DART AEROSPACE LTD		Work Order:	95231
Description: Crosstube Mid Aft (206L)		Part Number:	D206-667-207
Inspection Dwg: D206-667-247		Rev: A	Page 1 of 1

DART AEROSPACE LTD HAWKESBURY, ONTARIO, CANADA	
DRAWING NO. D206-667-247	REV. A SHEET 1 OF 4
TITLE CROSSTUBE ASSY (206L MID AFT)	SCALE NTS
COPYRIGHT © 2010 BY DART AEROSPACE LTD THIS DOCUMENT IS PRIVATE AND CONFIDENTIAL AND IS SUPPLIED ON THE EXPRESS CONDITION THAT IT IS NOT TO BE USED FOR ANY PURPOSE OR COPIED OR REPRODUCED IN ANY MANNER WITHOUT WRITTEN PERMISSION FROM DART AEROSPACE LTD

DRAWING NO. D206-667-247	TITLE CROSSTUBE ASS'Y (206L MID AFT)	REV. A	DART AEROSPACE LTD ENGINEERING ORDER		D.E.O. NO. D206-667-247-A-1	SHEET NO. SHEET 1 OF 1	SCALE NTS
DRAWN 97	CHECKED ASS	MFG. APPR. AD	APPROVED JMD		DE APPR. #		
DATE 11.07.15	DATE 11.07.20	DATE 11.07.21	DATE 11/07/21		DATE 11.7.21

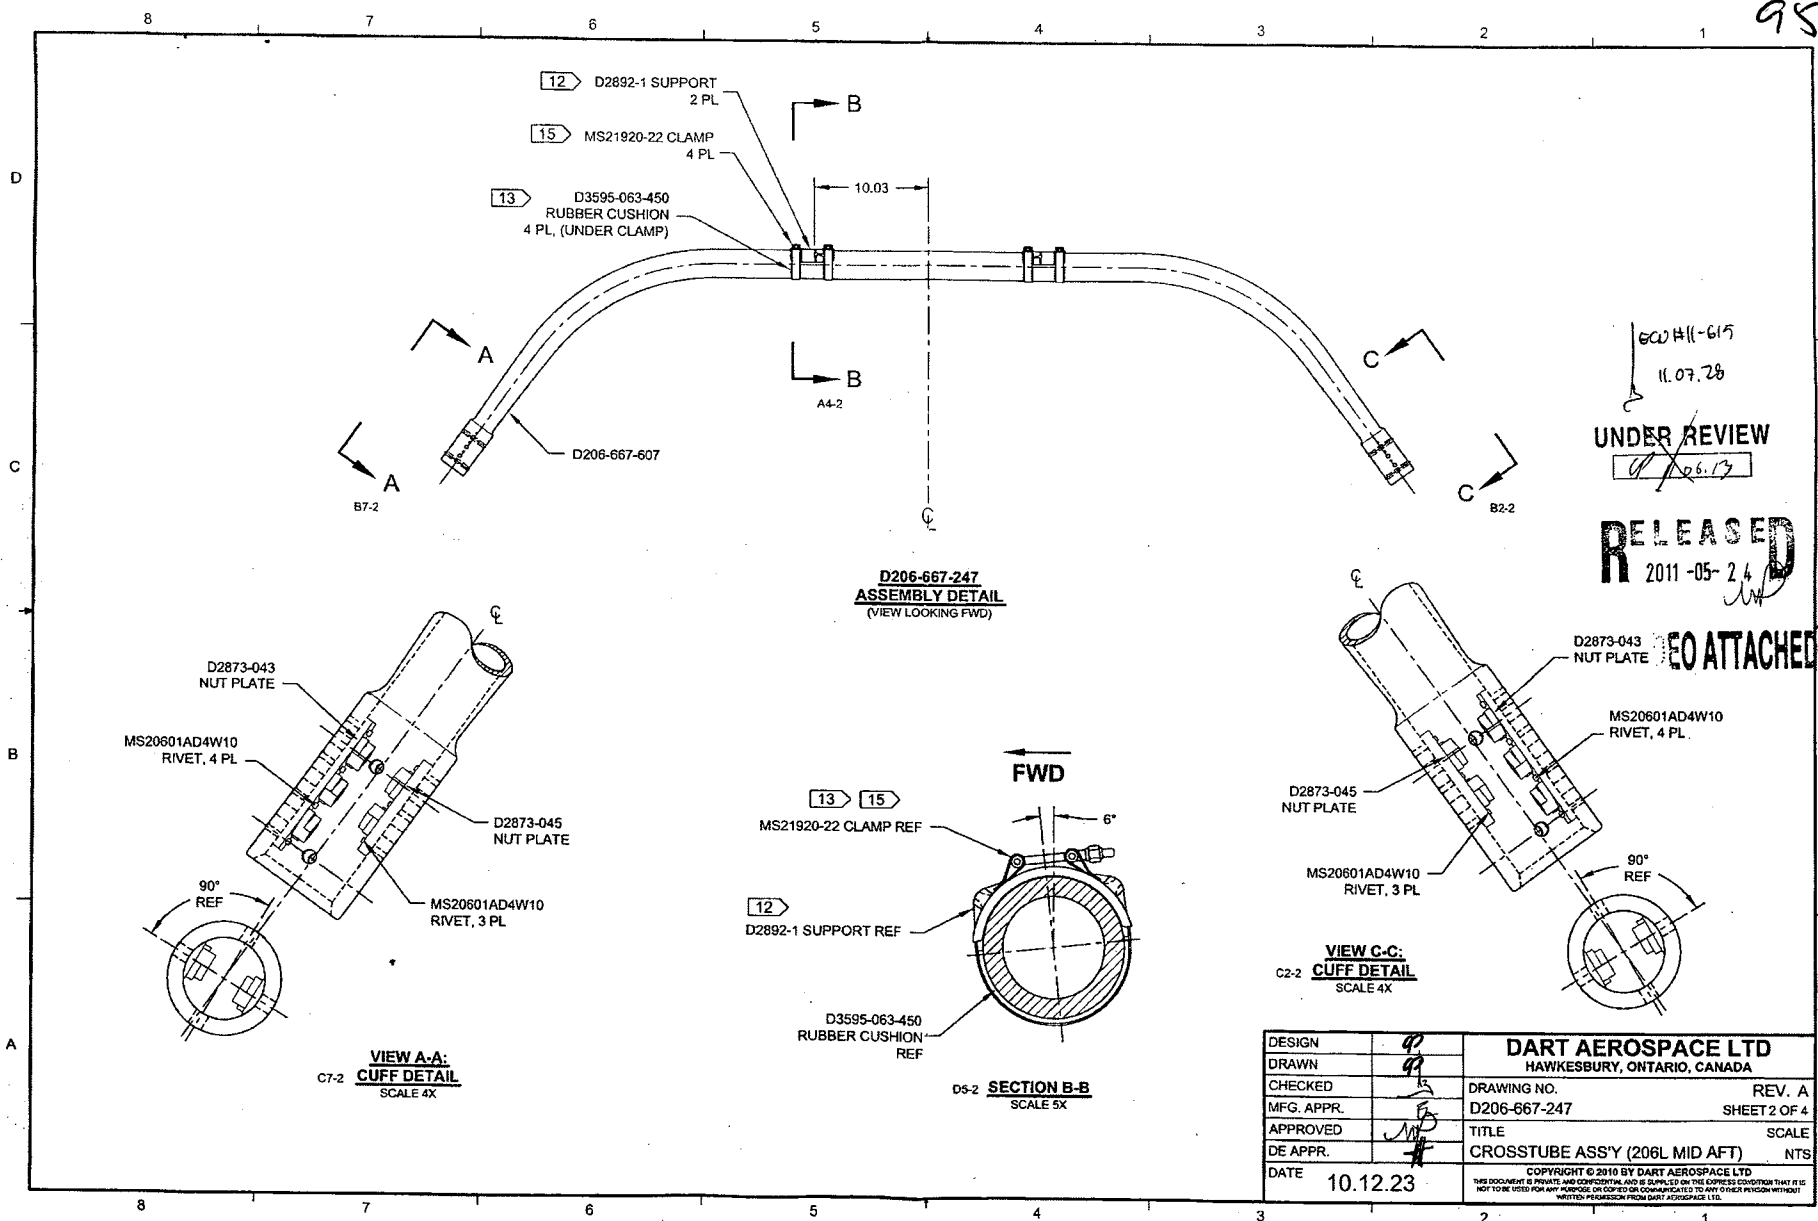
REPLACE MAGNOBOND WITH PROSEAL

NOTE 12 & 15. SHEET 1 IS AMENDED AS FOLLOWS:

- 12) TO INSTALL D2892-1 SUPPORT: ABRABE MATING SURFACE OF SUPPORT AND CROSSTUBE WITH 180-GRIT SANDPAPER AND REMOVE RESIDUE WITH MEK (OR EQUIVALENT). APPLY A 0.04" TO 0.07" THICK LAYER OF PROSEAL 890 CLASS B-2 (OR AMS-S-8802 CLASS B-2) SEALANT TO MATING SURFACE OF SUPPORT.
- 15) TORQUE CLAMPS 80 TO 100 IN-LB. ENSURE AT LEAST 1.5 THREADS SHOWING IN SAFETY AND THAT NUT HAS NOT BOTTOMED-OUT AFTER TORQUING. **PRIOR TO PACKAGING, RE-CHECK TORQUE ON CLAMPS AFTER PROSEAL 890 SEALANT HAS CURED FOR 72 HOURS.**
